HEIGHT/MASS/BULK - CURRENT SUBMITTED PLANNING APPLICATION

HEIGHT/MASS/BULK – PROPOSED REVISION

SECTION SHOWING COMPARATIVE HEIGHT MEASUREMENTS

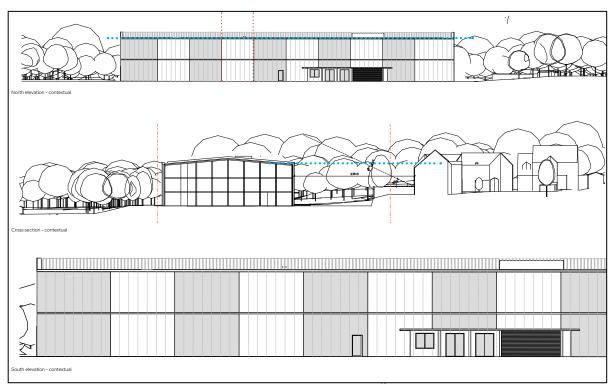
- Proposed revised and stepped back roof height is 1.428 metres lower than submitted application; and
- Proposed new step back means height is 3.105 metres lower than submitted application and below the height of existing building at nearest point to Kelso Court.

GROUND FLOOR PLAN – PROPOSED REVISION

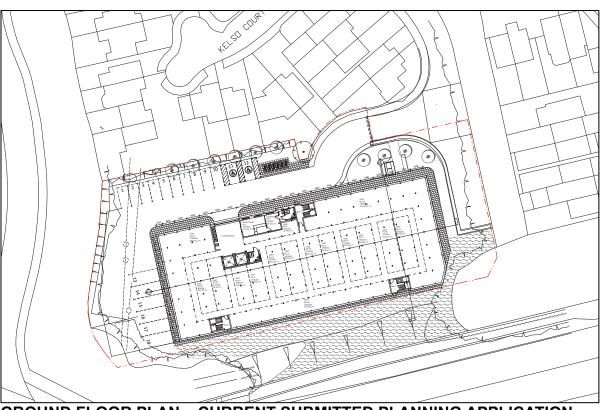
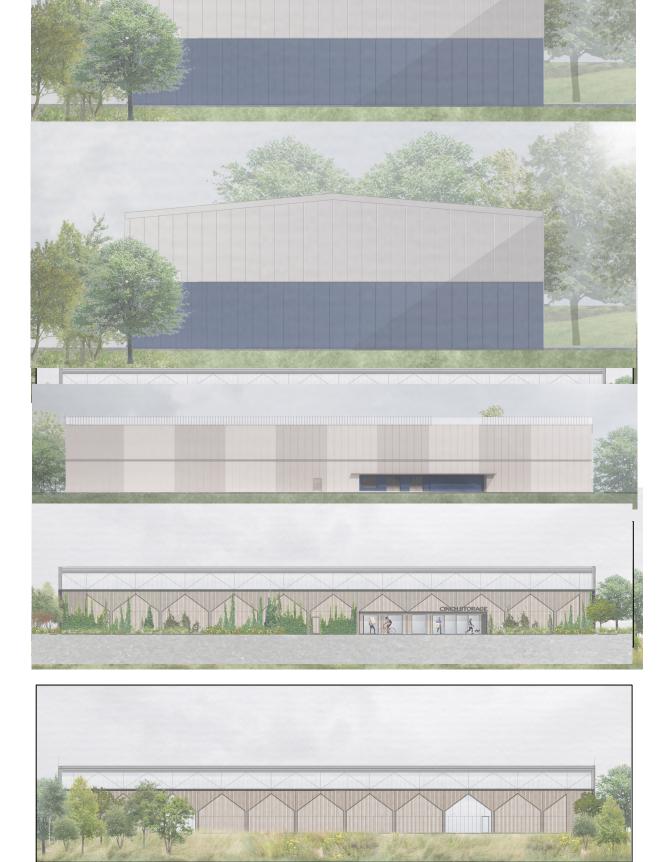
GROUND FLOOR PLAN – CURRENT SUBMITTED PLANNING APPLICATION

SIDE ELEVATION – PROPOSED REVISION

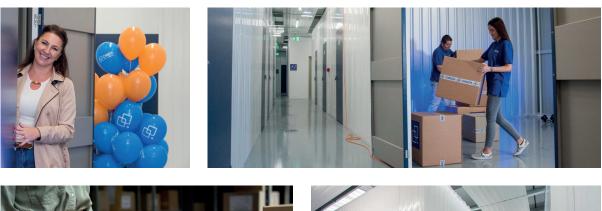
SIDE ELEVATION – SUBMITTED PLANNING APPLICATION
